SOLICITATION NUMBER: DEP15898
Addendum Number: No. 06

Addendum for the Wyoming Landfill Leachate Force Main Project issued to publish the following information.

DEP15898
Wyoming County Landfill
Additional Questions

TYPICAL CONCRETE THRUST BLOCKING DETAIL

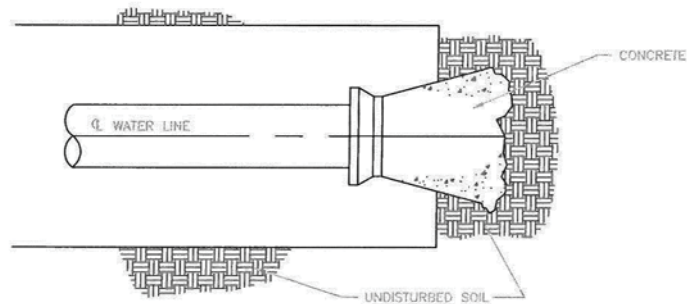
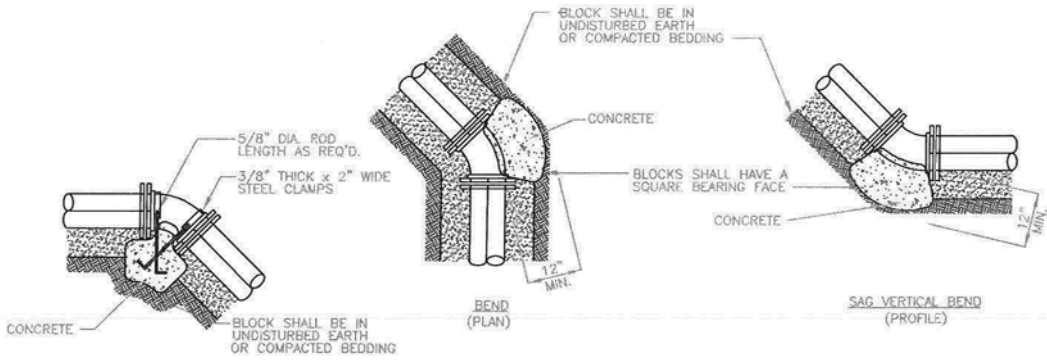
Question: Could you provide concrete block schedule and detail for forcemain & gravity line?

Answer: I assume that this is in regard to thrust blocks. Please see the attached thrust block detail
